Model Error Resolution Document

1. Document Number:	MDL-NBS-HS-000010	2. Revision/Addendum:	03/01	3. ERD:	01
---------------------	-------------------	-----------------------	-------	---------	----

4. Title:	Site-Scale Saturated Zone Transport
-----------	-------------------------------------

Figure A-5[b]. Americium Sorption Coefficients on Zeolitic Tuff versus Calculated Final Americium Concentration in Solution

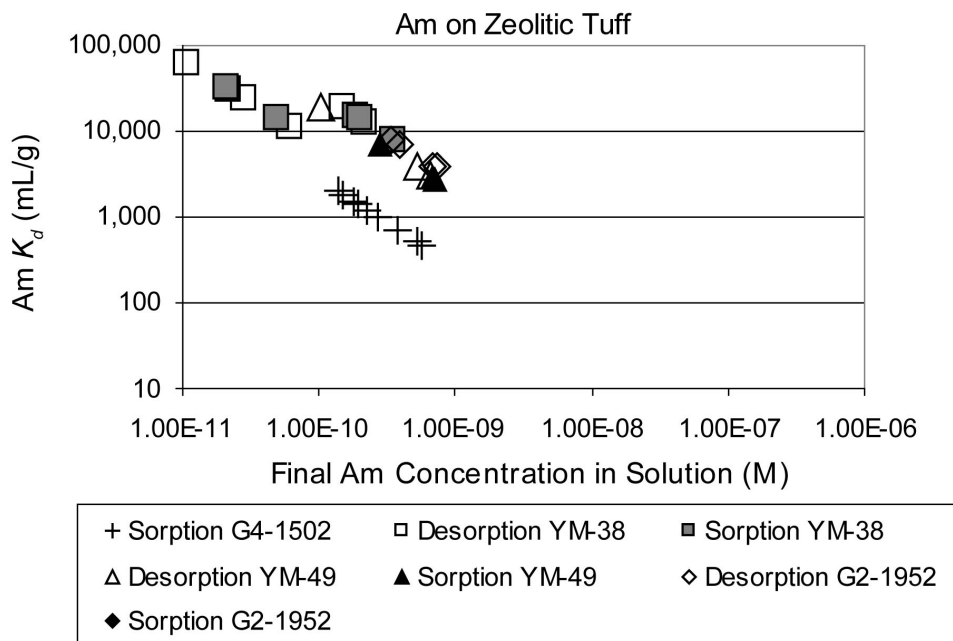
- DTN: LA0305AM831341.001 (titled "1977 to 1987 Sorption Measurements of Am, Ba, Cs, Np, Pu, Pa, Sr, Th, and U with Yucca Mountain Tuff Samples) and DTN: LA0310AM831341.001 (titled "Sorption/Desorption Measurements of Cesium on Yucca Mountain Tuff") were superseded by new DTN: LA0803AM831341.001 (titled "1977 to 1987 Sorption Measurements of Am, Ba, Cs, Np, Pu, Pa, Sr, Th, and U with Yucca Mountain Tuff Samples"). The following are results of the analysis resulting from these changes:
 - Reassignment of the rock-type for sample JA-18 from zeolitic to vitric. This change required the removal of sorption and desorption K_d values associated with this sample in Figure A-5, and deletion of the sentences referencing sample JA-18

in the first paragraph of Section A7.1.2. The legend of the revised Figure A-5 was also edited to correct a typographical error in two sample identifiers. The K_d distributions remain unchanged.

The first paragraph of Section A7.1.2 and Figure A-5 are replaced by the following:

Figure A-8[b]. Cesium Sorption Coefficients on Devitrified Tuff versus Calculated Final Cesium Concentration in Solution

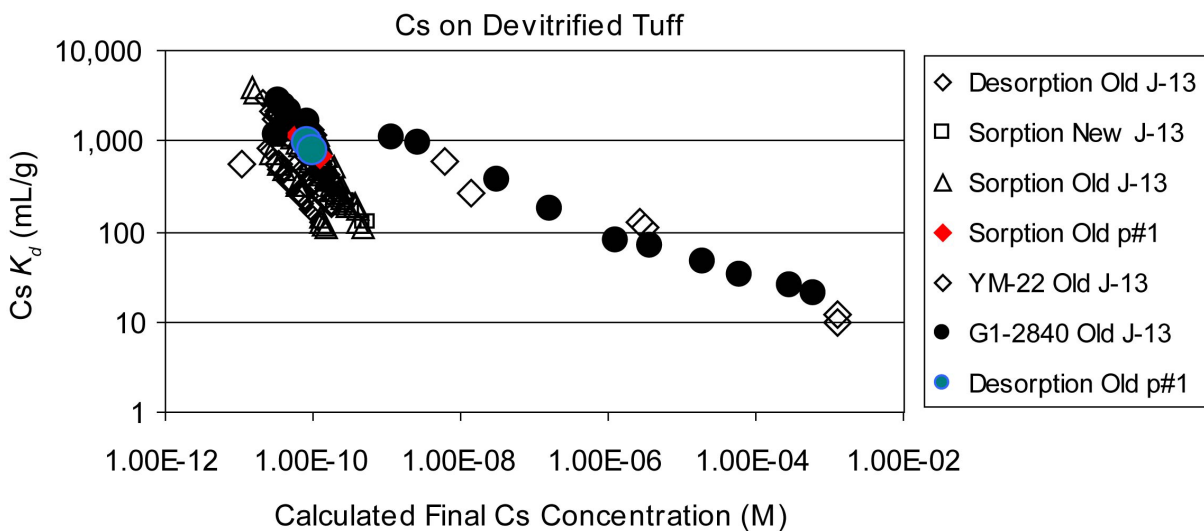
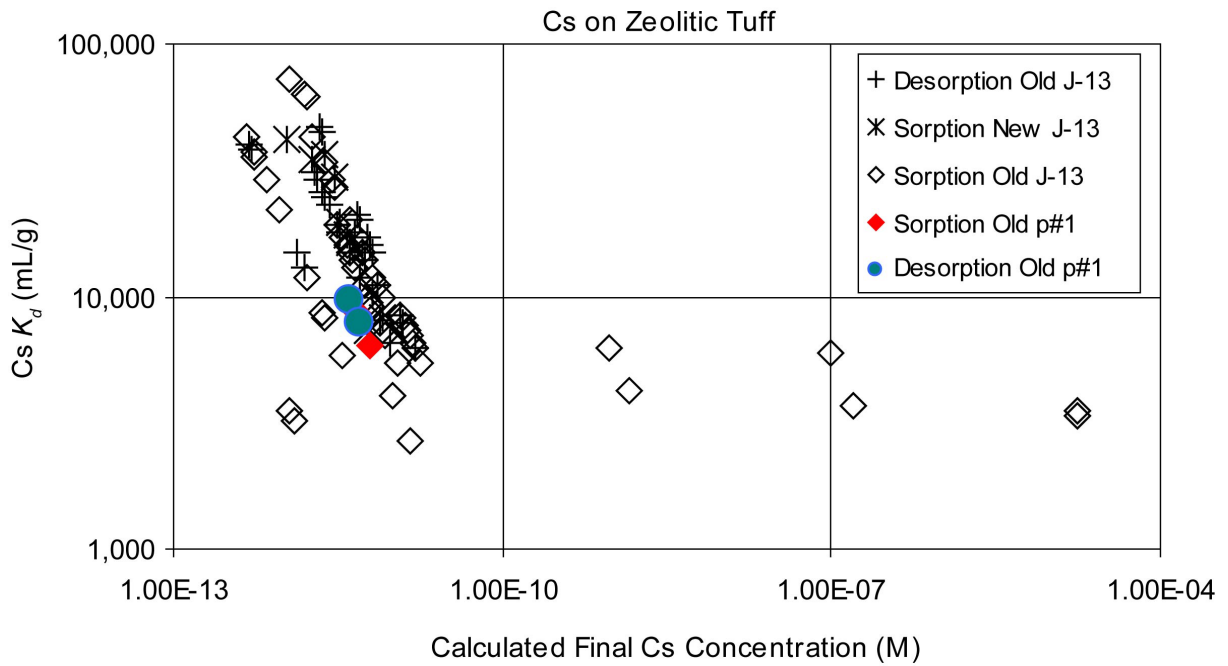
- Correction to calculated final Cs concentration in solution, reported in Column O of the superseding DTN LA0803AM831341.001. This change required corrections to Sections A7.2.1, A7.2.2, Figure A-8 and Figure A-11. Additionally, editorial changes were made to the source descriptions for Figures A-8 and A-9 to reflect that the cited data were shifted by one column in the superseding DTN. The K_d distributions remain unchanged.

Figures A-8 and A-11 are replaced by the following:

Figure A-21[b]. Plutonium Sorption Coefficients on Devitrified Tuff versus Calculated Final Plutonium Concentration in Solution

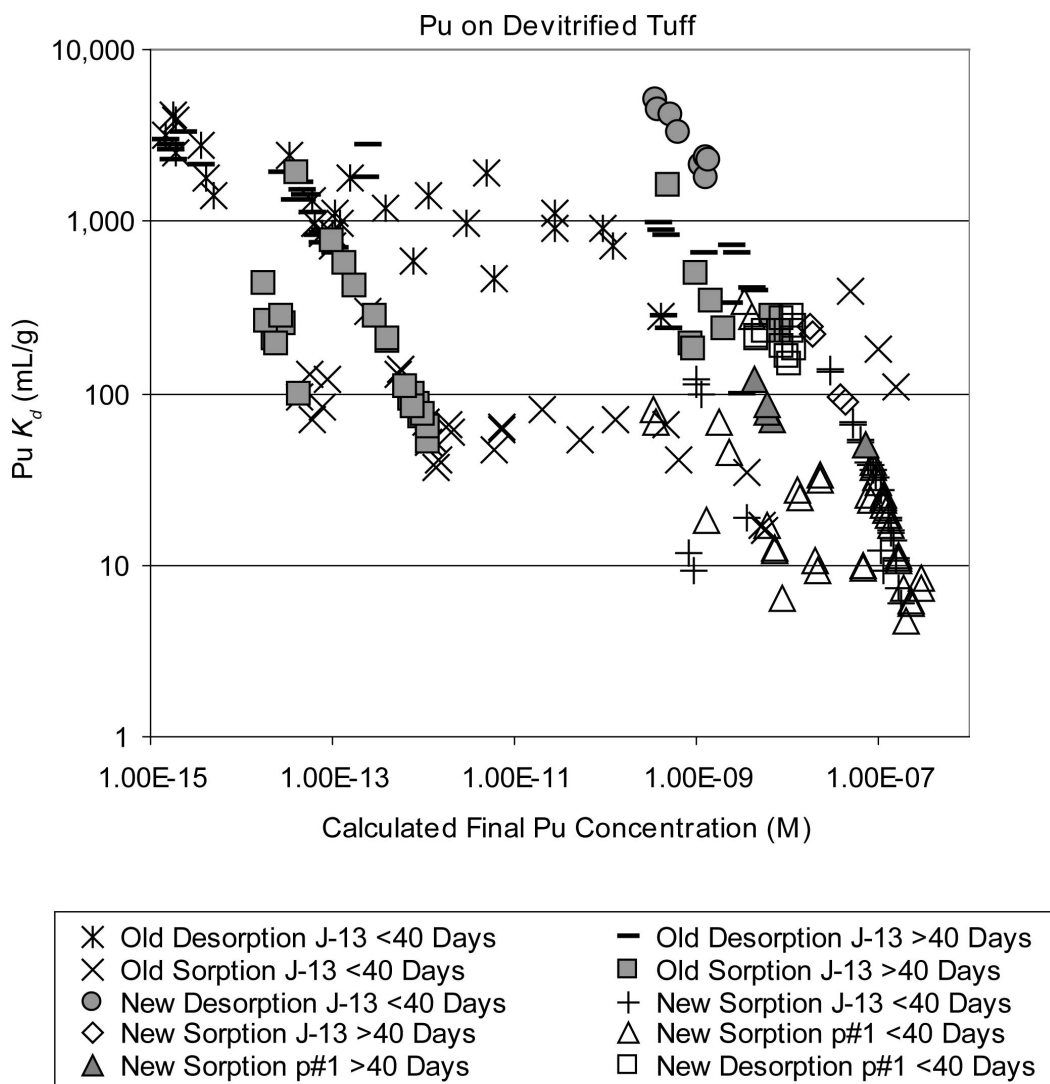
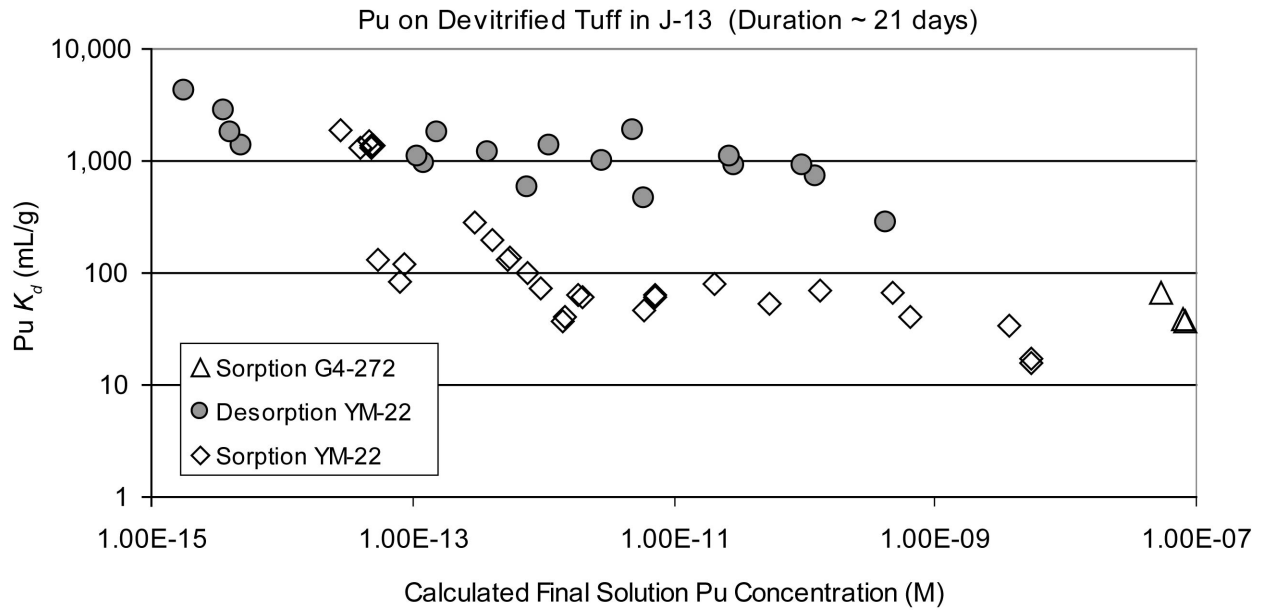
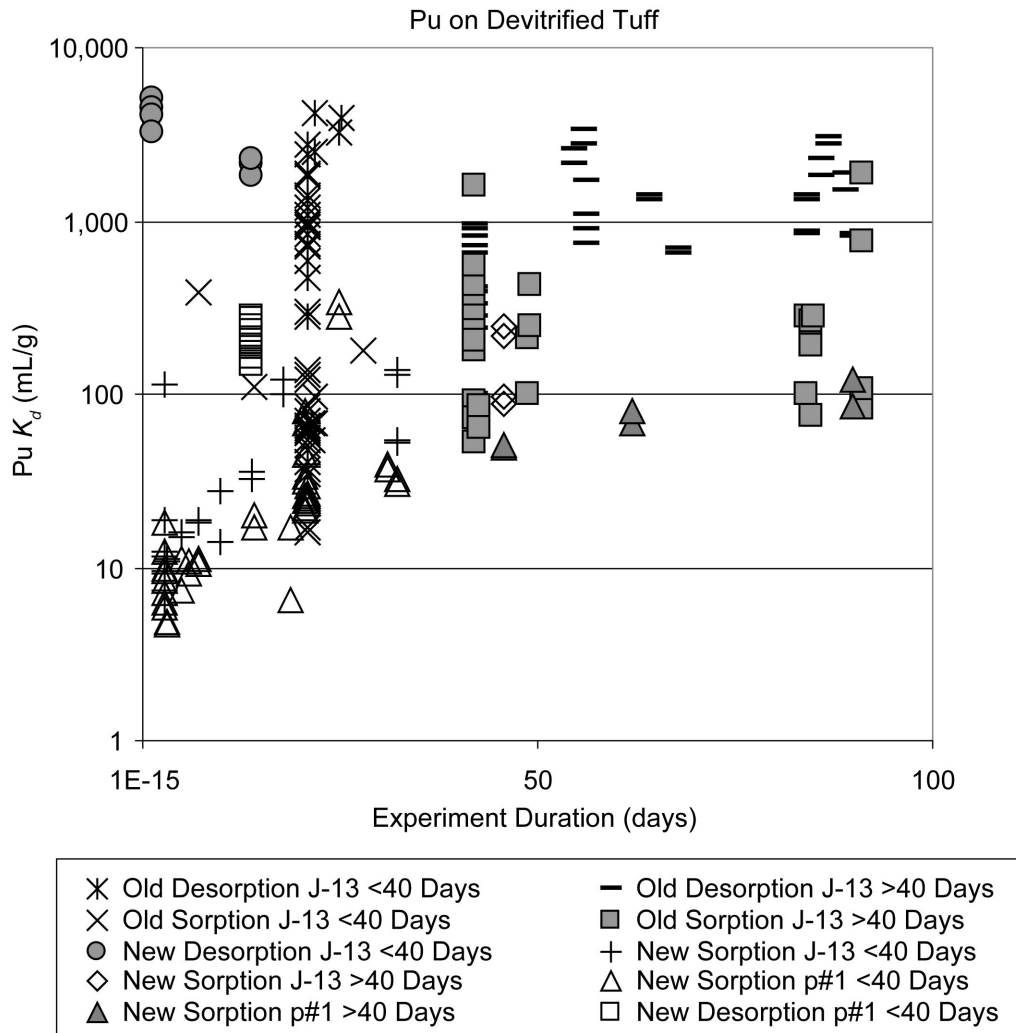
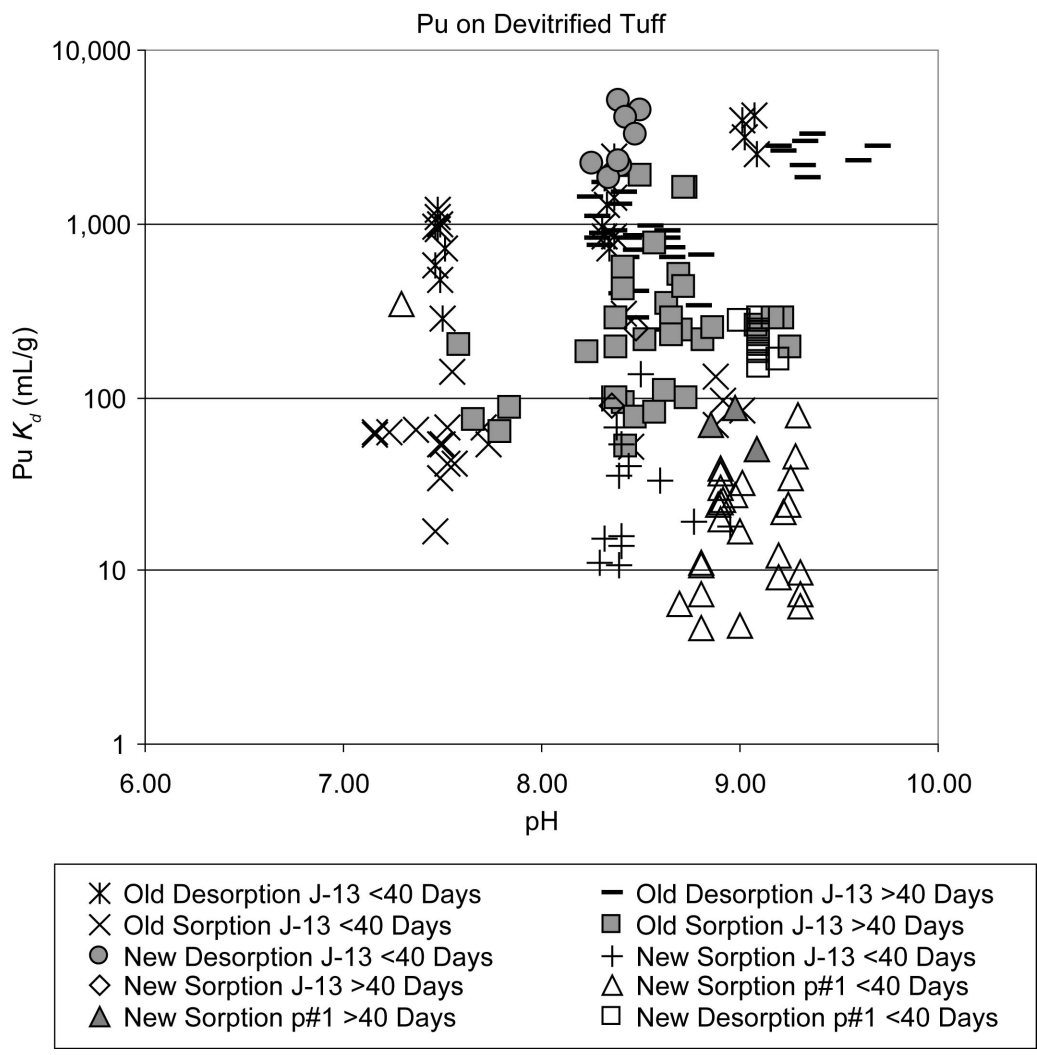
lasting about 14 days. Corrections were made to Sections A7.4.1 and A7.4.2, Figures A-21 through A-24, and Figures A-26 through A-28. Figure A-21 was also revised to include the plotting category, “New Sorption p#1 > 40 Days,” which had been left out of the original figure. The K_d distributions are unchanged.

Figures A-21, A-22, A-23, and A-24 are replaced by the following:

Figure A-35[b]. Barium and Radium Sorption Coefficients on Zeolitic Tuff in J-13 Well Water versus Experiment Duration for Sorption (Forward) and Desorption (Backward) Experiments

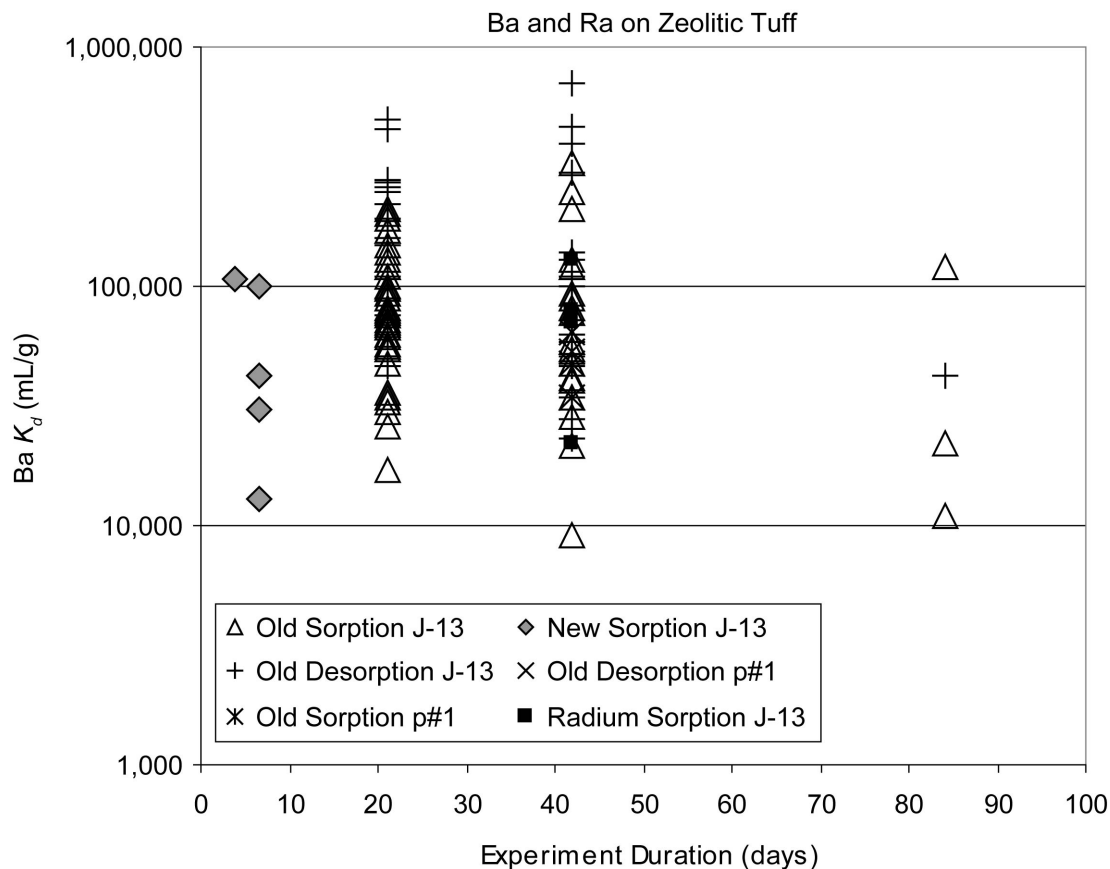
The following additional error was noted in Figures A-35 and H-1: the point with the highest value for “Sorption J-13 New” data, denoted by open squares in the figures, is not listed in the source DTNs.

- An error was noted in Figure A-35: the point with the highest value for “Sorption J-13 New” data, denoted by open squares in the figures, is not listed in the source DTNs. This point was removed from the Figure A-35. The data ranges remain the same. The K_d distribution remains unchanged.

Figure A-35 is replaced by the following:

Figure A-42[b]. Strontium Sorption Coefficients on Devitrified Tuff versus Calculated Final Strontium Concentration in Solution

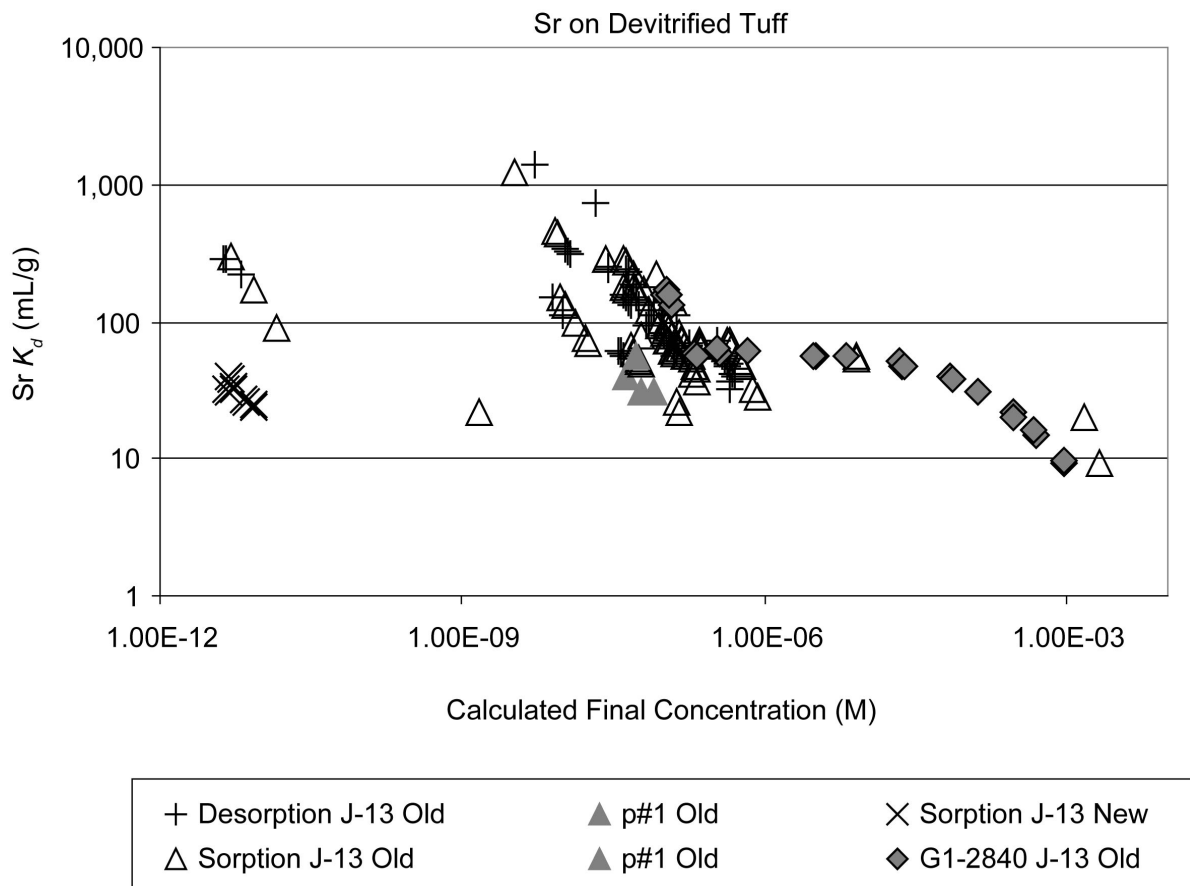
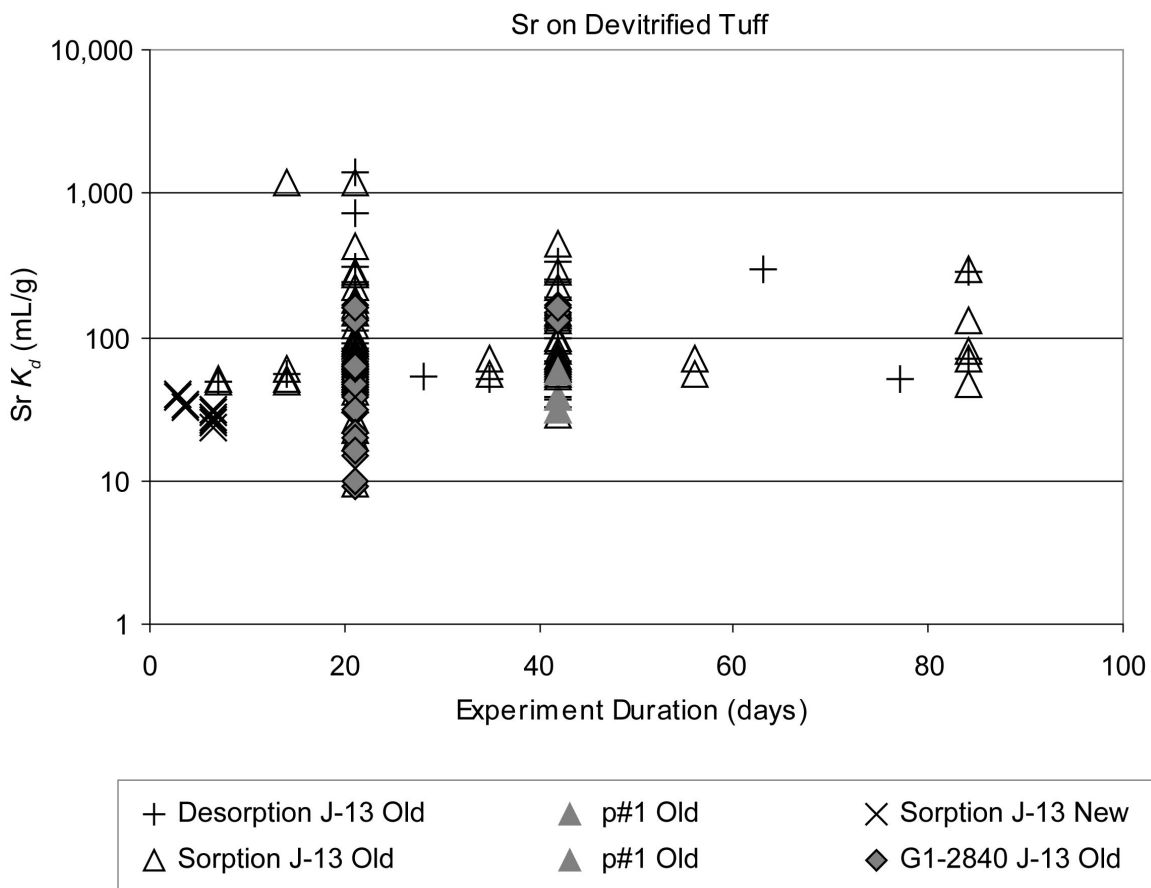
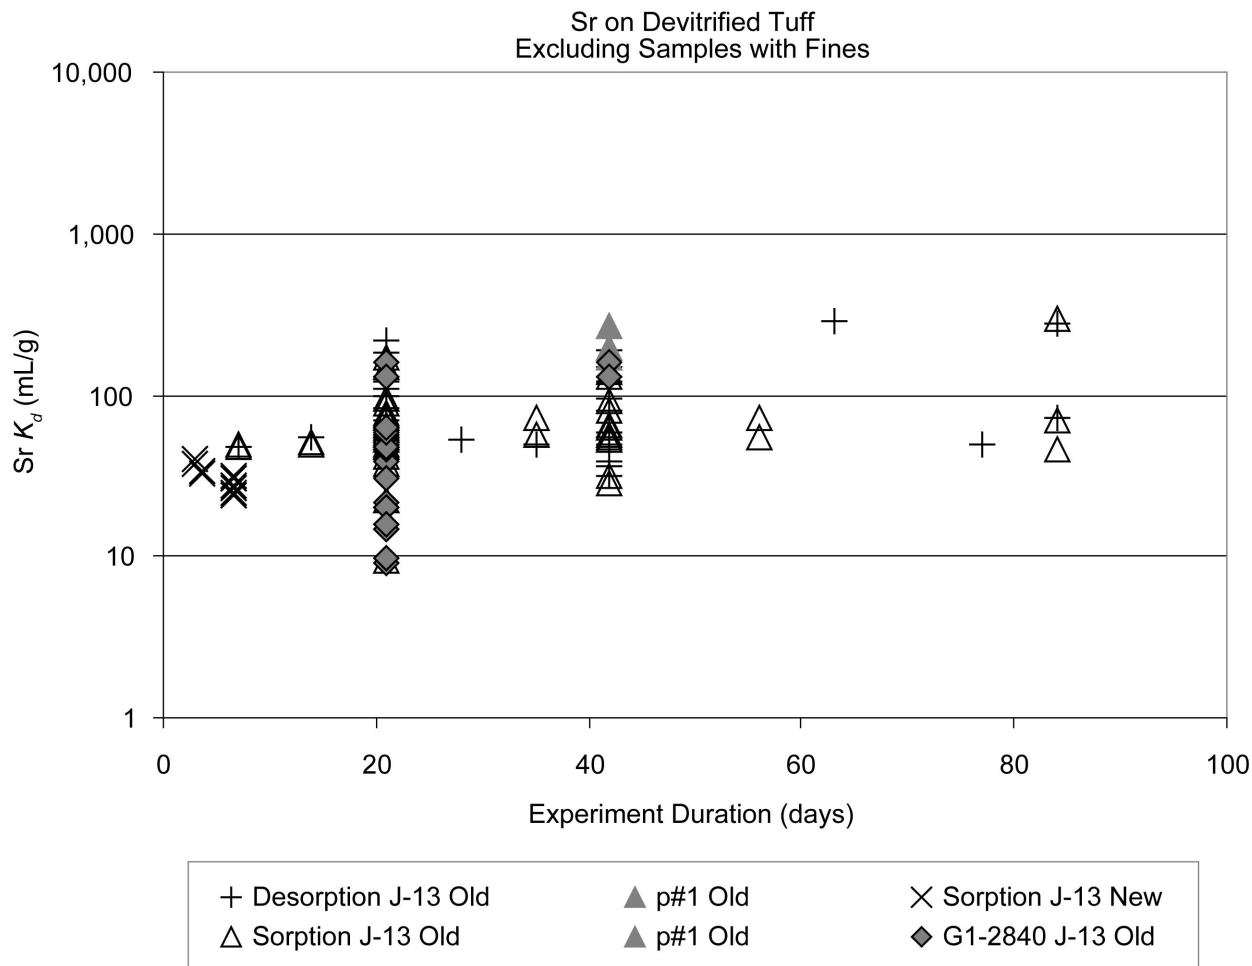
- Correction of calculated values K_d and the calculated final Sr concentration in solution for sample G1-2901. This resulted in revision of Section A7.8.1 and the figures A-42, A-43, and A-44, as discussed below. Figures A-43 and A-44 also include point (63, 290) which was mistakenly omitted in the previous version of the figure. This point falls within the range of the data already plotted in the figure. The K_d distributions remain unchanged.

Figures A-42, A-43, and A-44 are replaced by the following:
